# Access Compliance Report

## Public Rights-of-Way

Intersection ID: 54260	Main Street: BALLANTYNE_COMMONS_PY	Cross Street: BLACK_FOREST_LN	Location: SE
ADA ID: AF1B83C2B011	Ramp Type: Perp	Initial Pass/Fail: Fail	Overall Compliance: No
Severity Score: 25			
Codes/Mitigation Info/Possible Solution		Field Measurements/Component Compliance

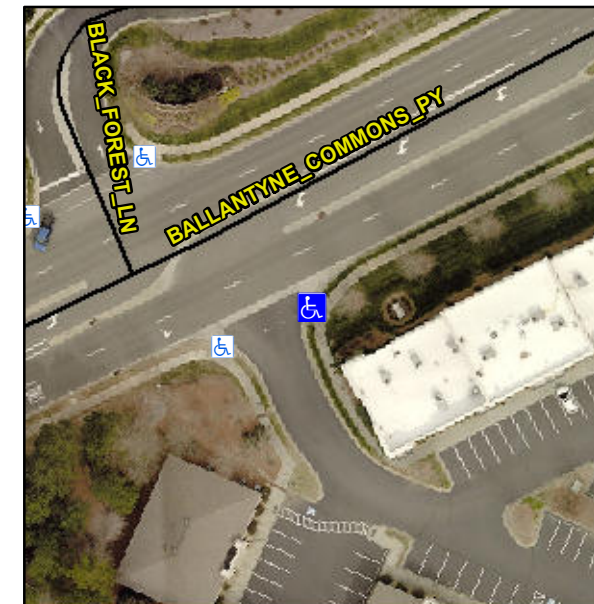
**Remove & Replace Entire Ramp.**

**Not Found, R304.5.3**

Compliance	Description	Data	Compliance	Description	Data
N/A	Ramp Length (in)	115.5	Yes	Ramp Slope (%)	7.5
Yes	Ramp Width (in)	51.0	No	Ramp XSlope (%)	11.3
N/A	Flare Type LT	N/A	N/A	Flare Type RT	N/A
N/A	Flare Slope LT (%)	N/A	N/A	Flare Slope RT (%)	N/A
N/A	Flare Traversable LT?	N/A	N/A	Flare Traversable RT?	N/A
N/A	Landing Length (in)	N/A	N/A	DWS Provided?	N/A
N/A	Landing Width (in)	N/A	N/A	DWS Contrast?	N/A
N/A	Landing Slope (%)	N/A	N/A	DWS Length (in)	N/A
N/A	Landing X Slope (%)	N/A	N/A	DWS Full Width?	N/A
N/A	Landing Curb? (Y/N)	N/A	N/A	DWS Offset (in)	N/A
N/A	Shared Landing?	N/A			
N/A	Gutter Ponding?	N/A	N/A	Gutter Slope (%)	N/A
N/A	Gutter Lip Ht (in)	N/A	N/A	Gutter X Slope (%)	N/A
N/A	Painted X Walk1?	No	N/A	Painted X Walk2?	N/A
	X Walk 1 Direction	To W		X Walk 2 Direction	N/A
N/A	X Walk 1 Width (in)	N/A	N/A	X Walk 2 Width (in)	N/A
	X Walk 1 Slope (%)	1.2		X Walk 2 Slope (%)	N/A
	X Walk 1 X Slope (%)	11.4		X Walk 2 X Slope (%)	N/A
